HILL VALLEY - PHASE 2B

CITY PROJECT NO. 15860
CONTRACT NO. 9680

REVISION 1 - 04/29/26

REVISION 2 - 05/28/26

15860	MADISON, WI	9680	CONTRACT NO.:
PLAN & PROFILE - S PLEASANT VIEW ROAD			
HILL VALLEY - PHASE 2B			
M:\DESIGN\Projects\15860\CAD\Streets\15860EN-PnP.dwg			
15860		P-8

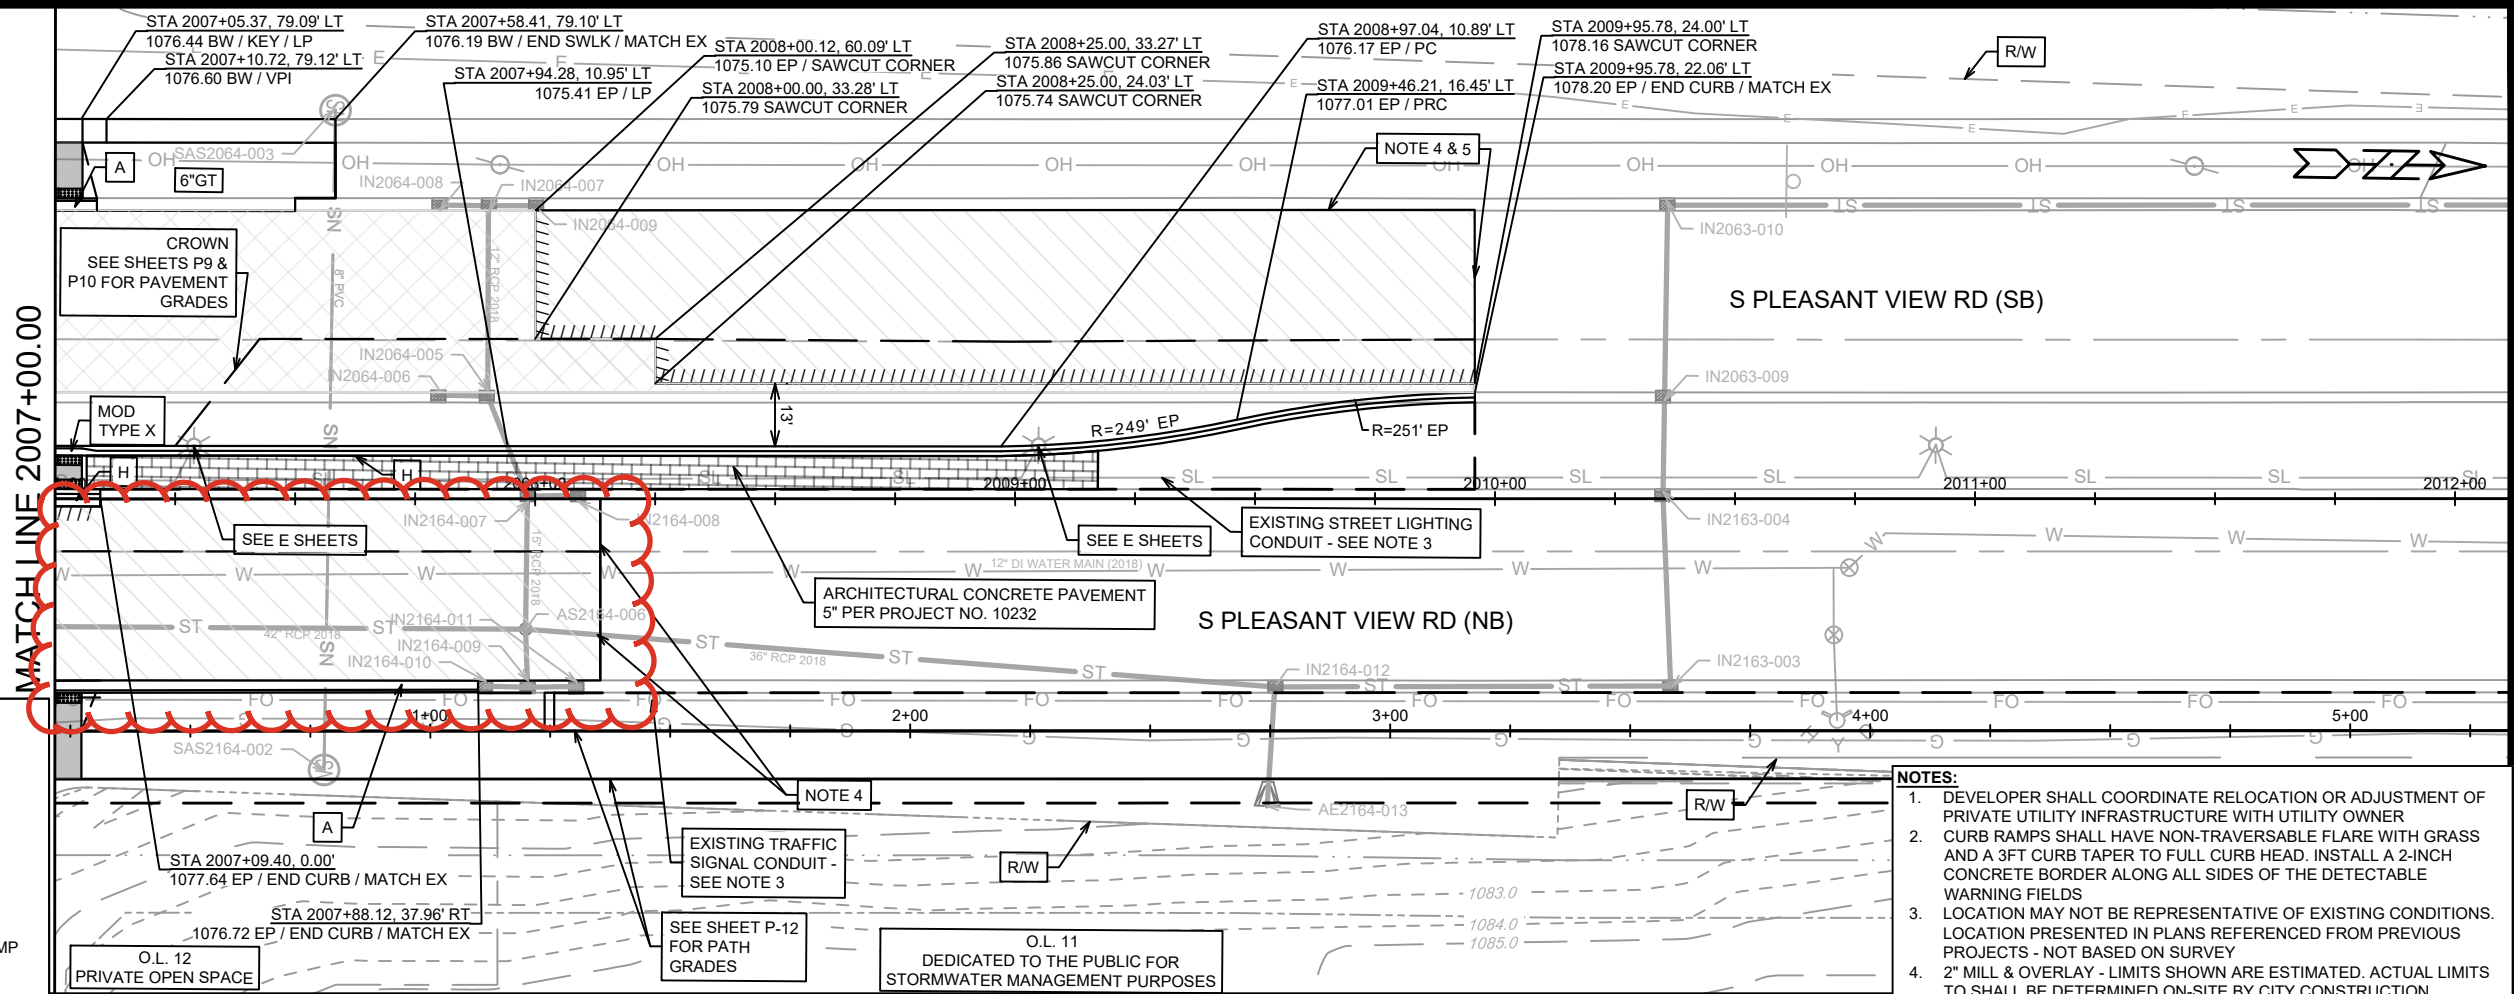
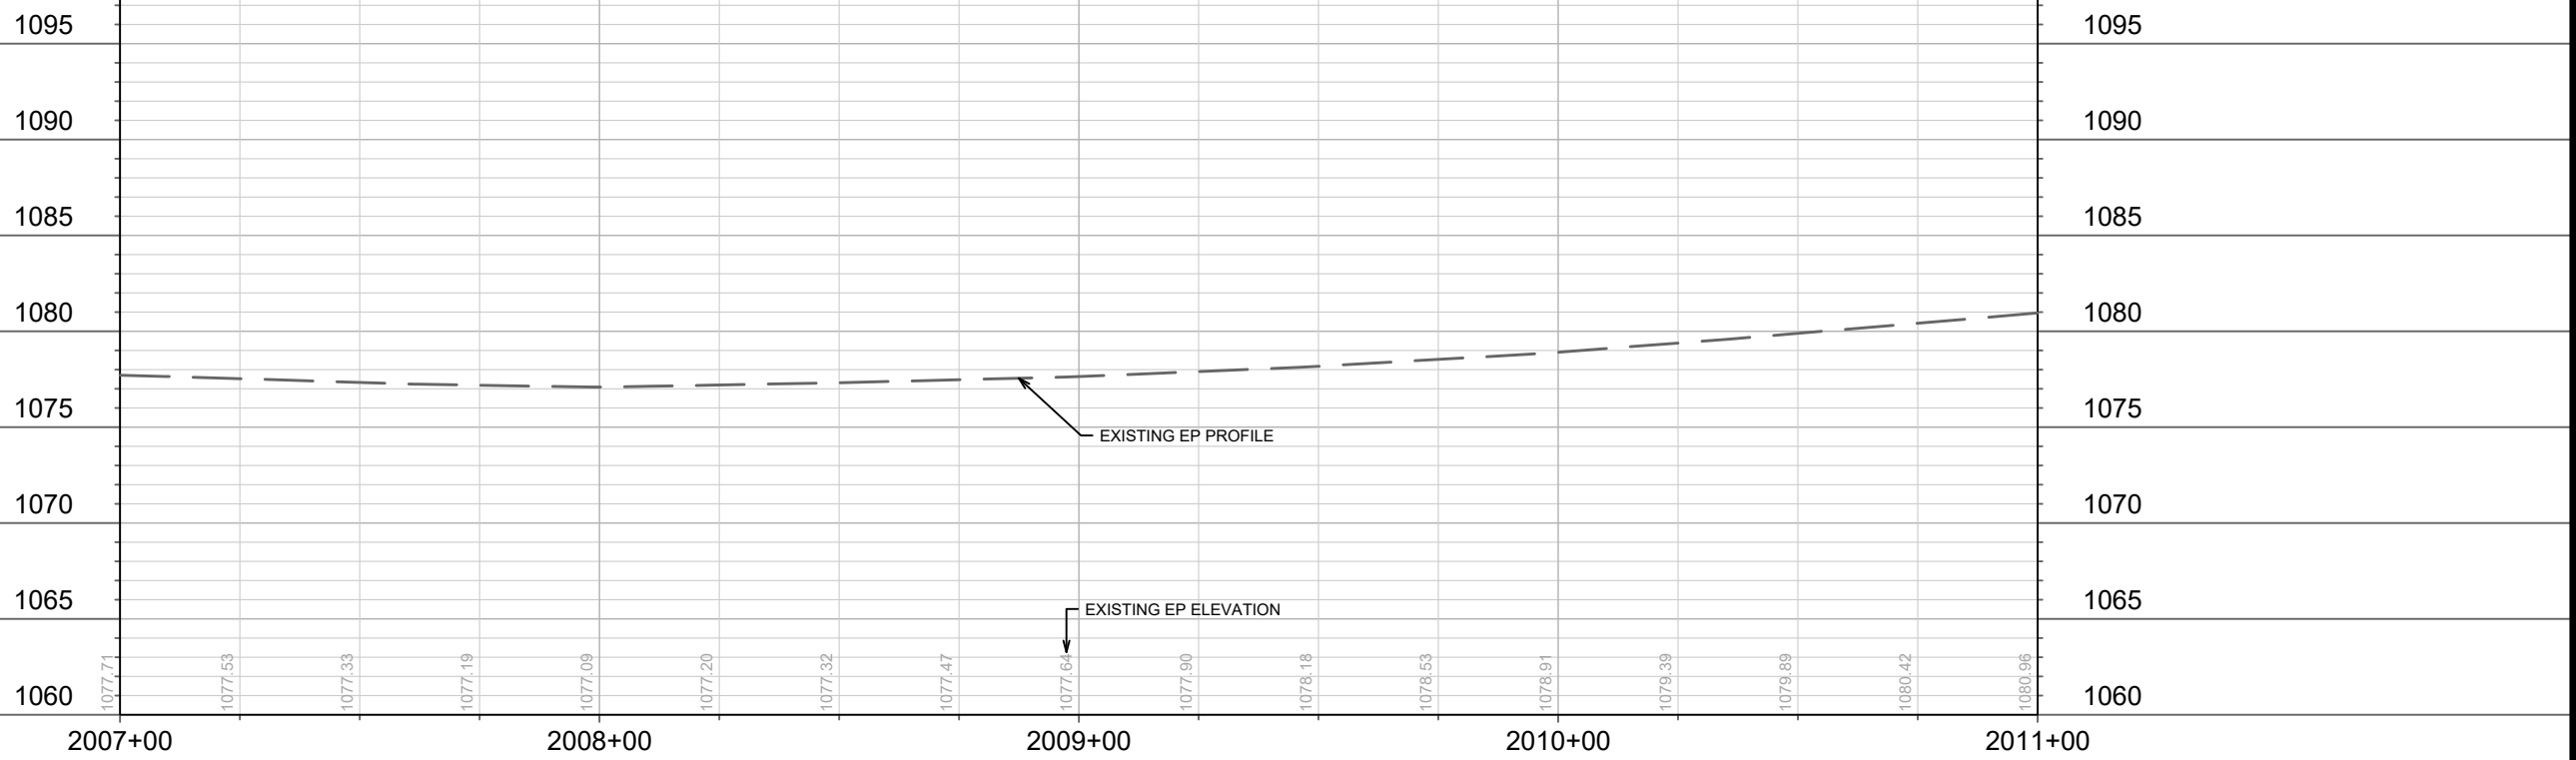
REVISION 2 - GCIT - 05/28/26
 - UPDATED LEGEND
 - UPDATED PAVEMENT RESTORATION AND CURB REPLACEMENT LIMITS
 - ADDITIONAL R/W LABELS

15860
 MADISON, WI
 CONTRACT NO: 9680
 PLAN & PROFILE - S PLEASANT VIEW ROAD (SIDEWALK)
 HILL VALLEY - PHASE 2B
 CITY OF MADISON WISCONSIN
 15860
 P-11

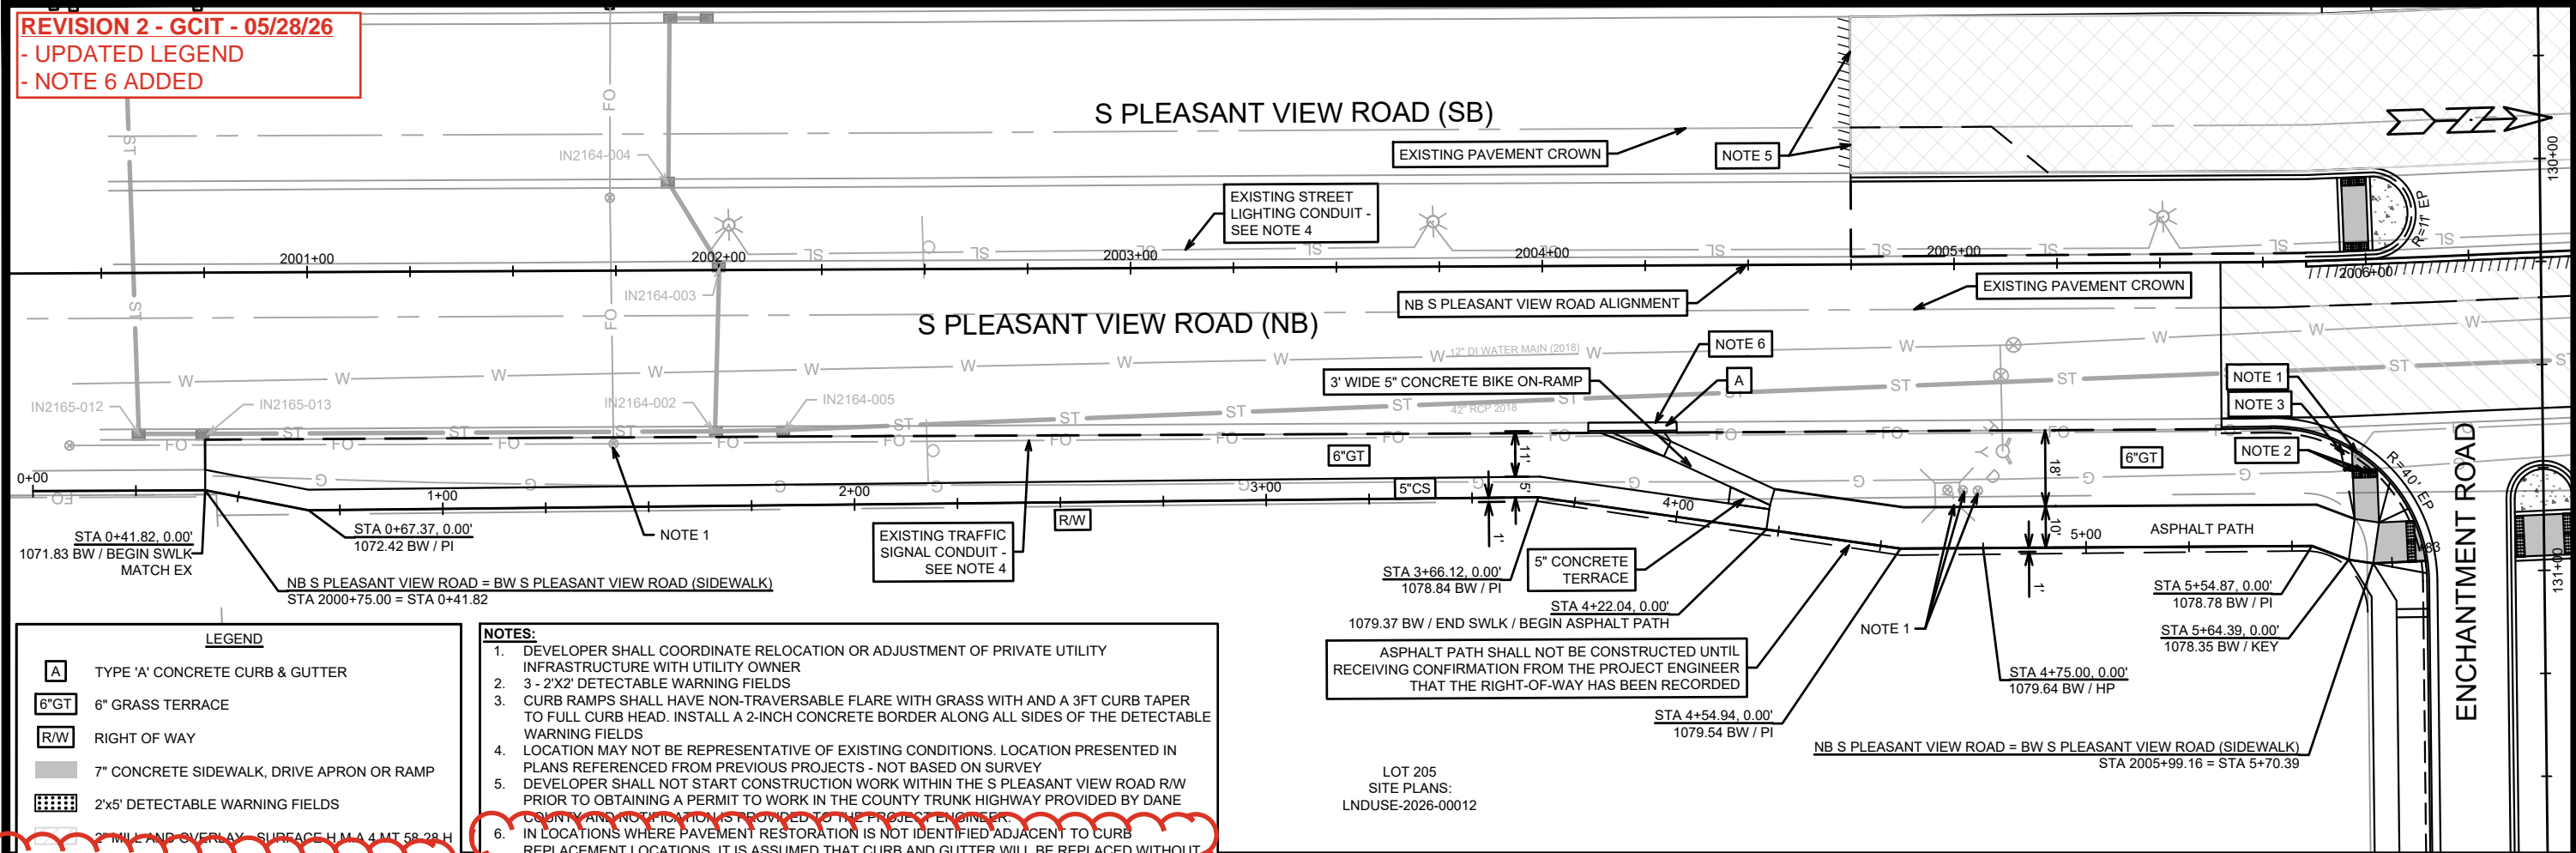
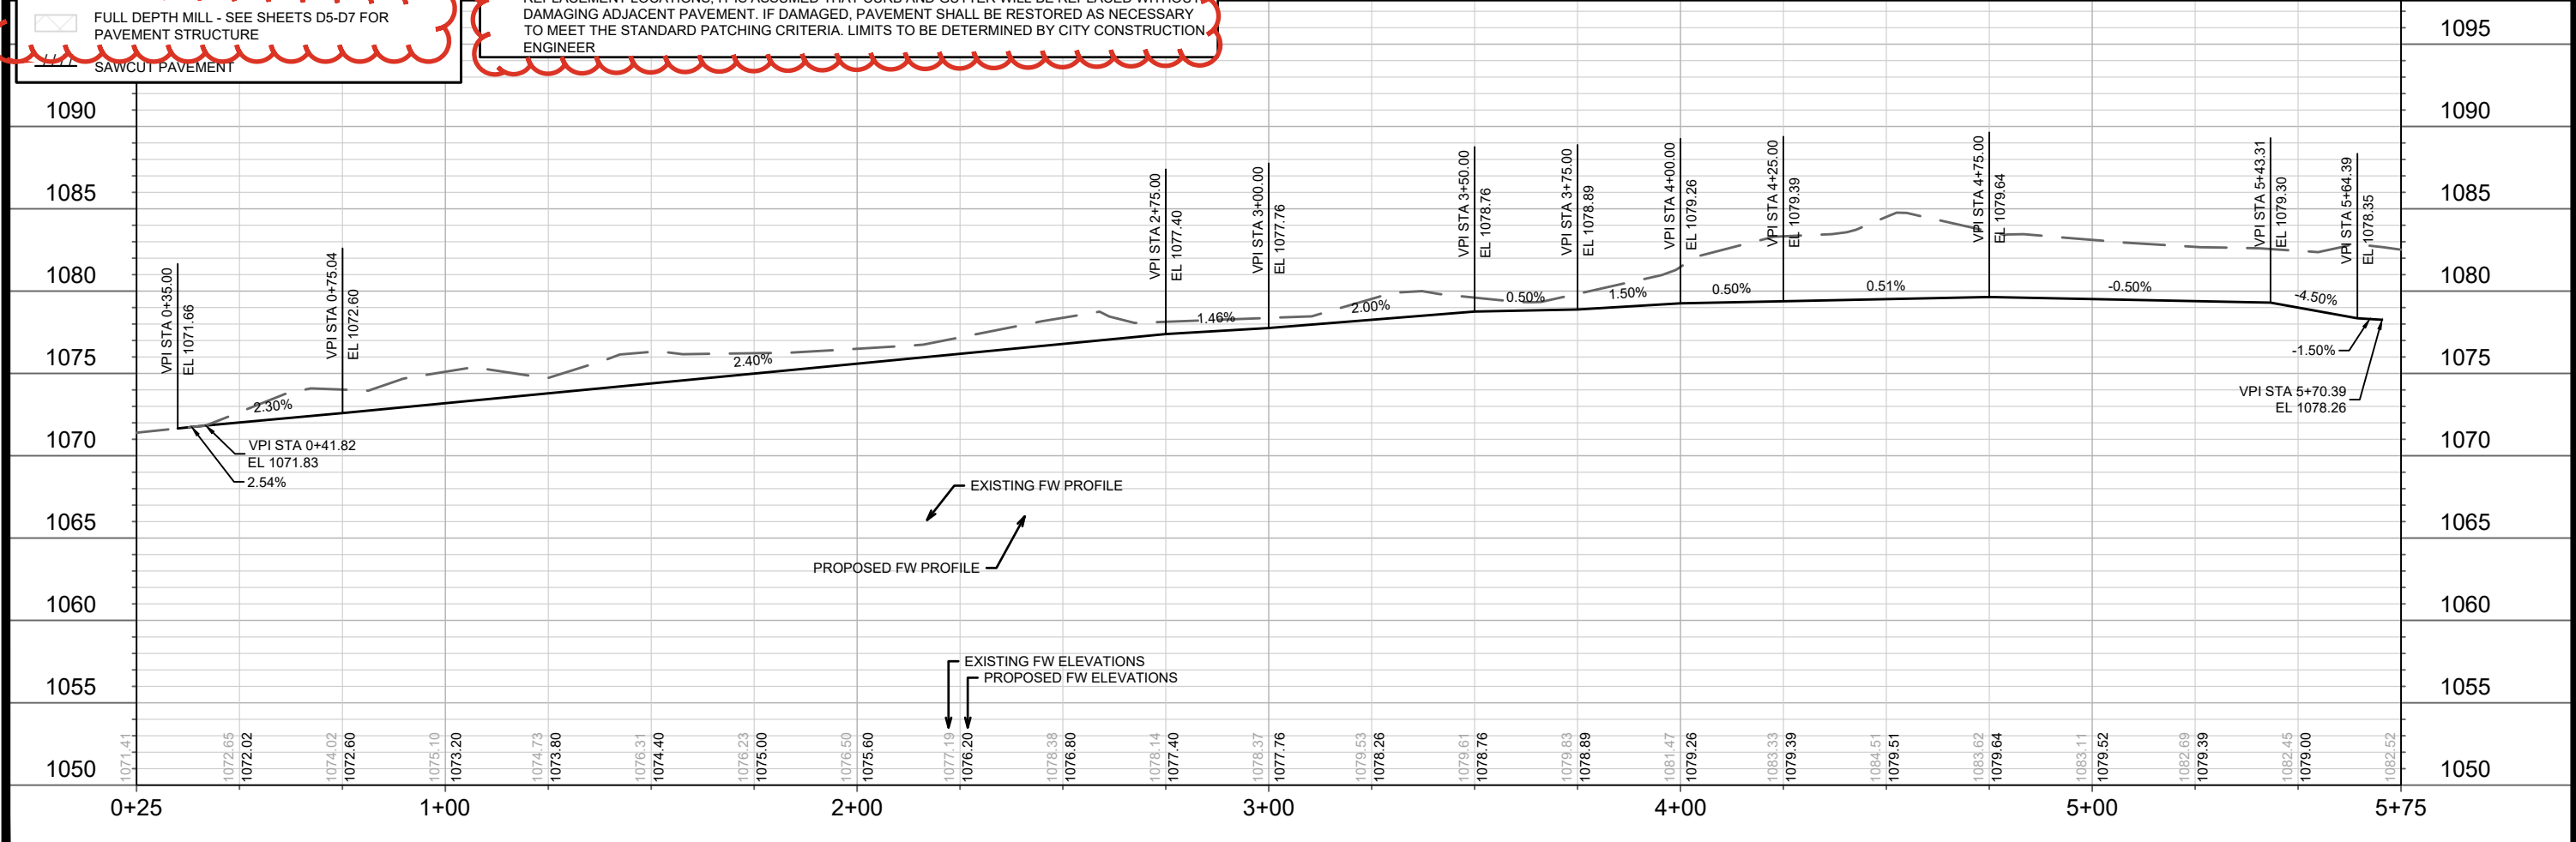
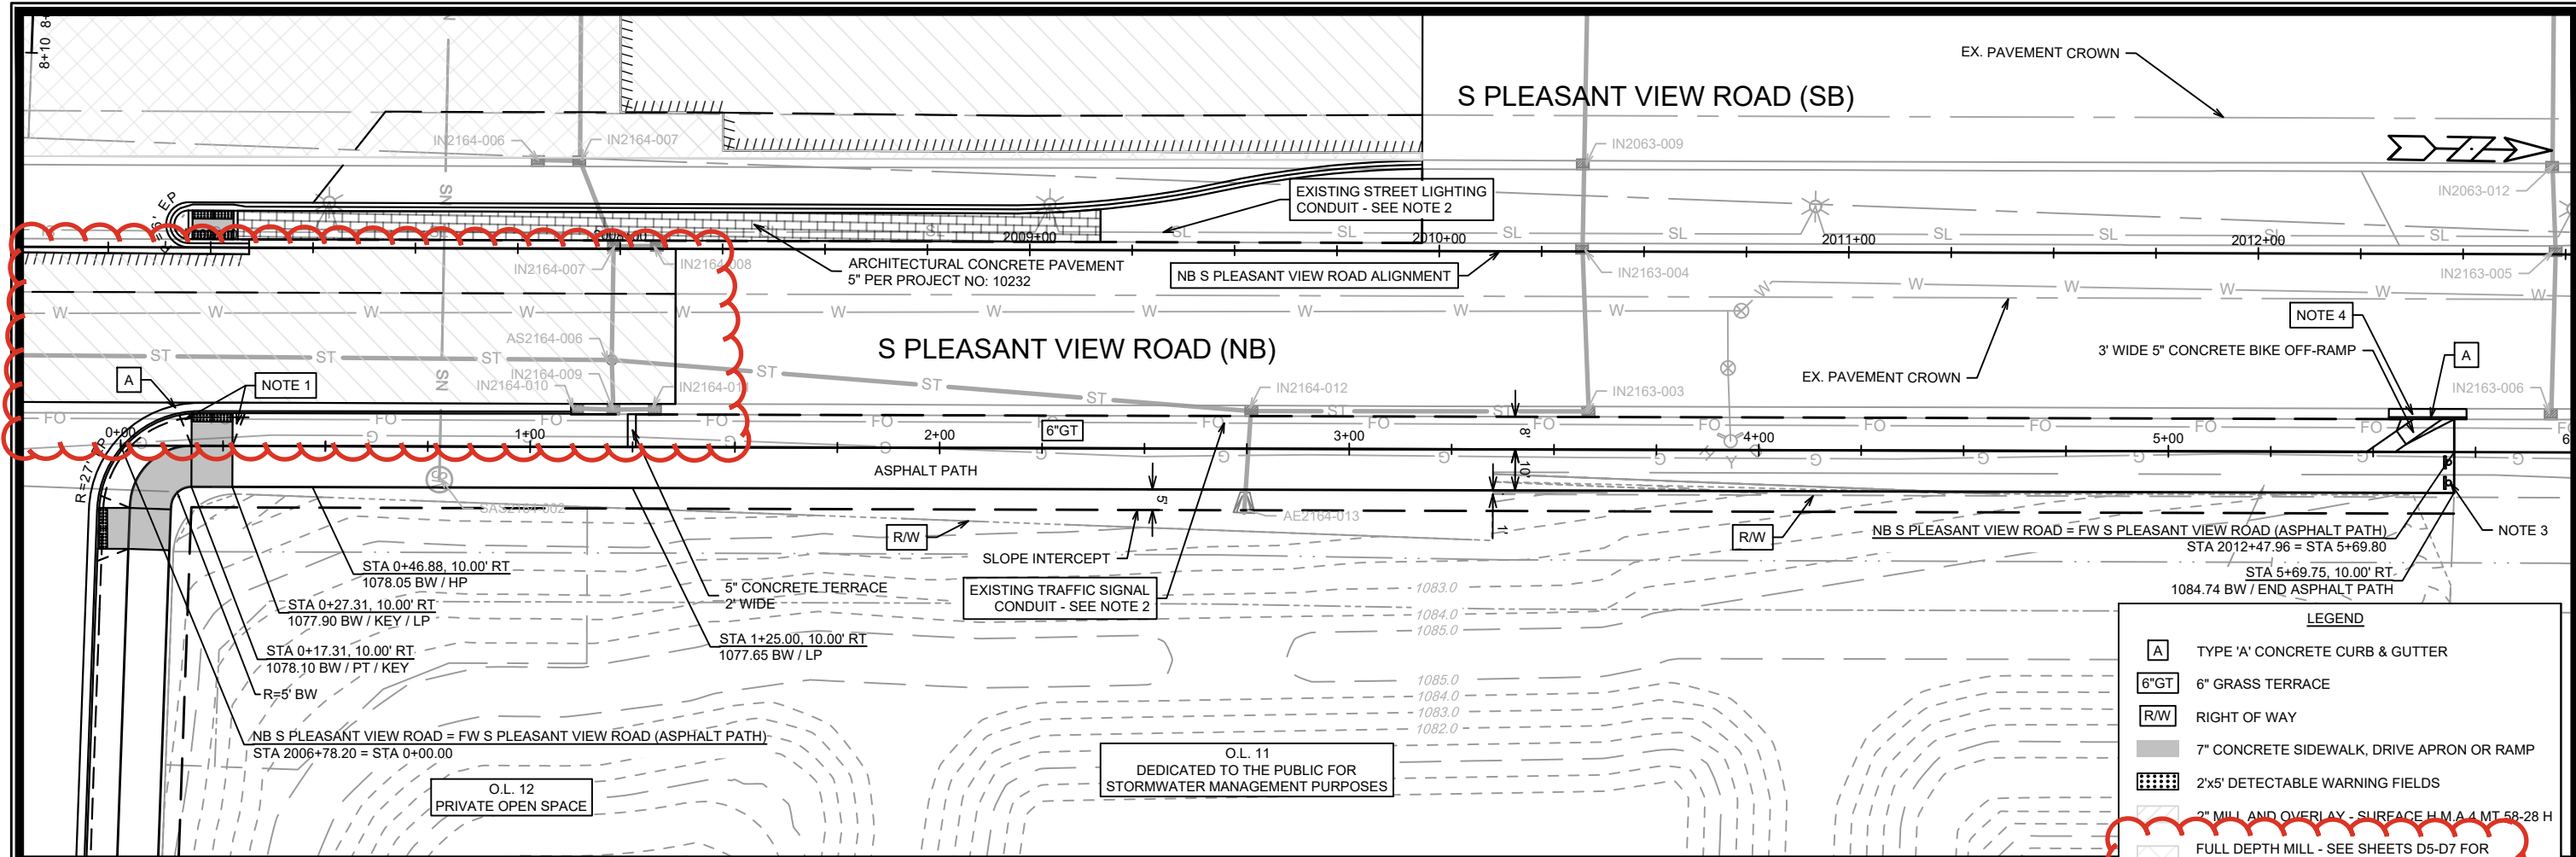
REVISION 2 - GCIT - 05/28/26
 - UPDATED LEGEND
 - NOTE 6 ADDED

6. IN LOCATIONS WHERE PAVEMENT RESTORATION IS NOT IDENTIFIED ADJACENT TO CURB REPLACEMENT LOCATIONS, IT IS ASSUMED THAT CURB AND GUTTER WILL BE REPLACED WITHOUT DAMAGING ADJACENT PAVEMENT. IF DAMAGED, PAVEMENT SHALL BE RESTORED AS NECESSARY TO MEET THE STANDARD PATCHING CRITERIA. LIMITS TO BE DETERMINED BY CITY CONSTRUCTION ENGINEER
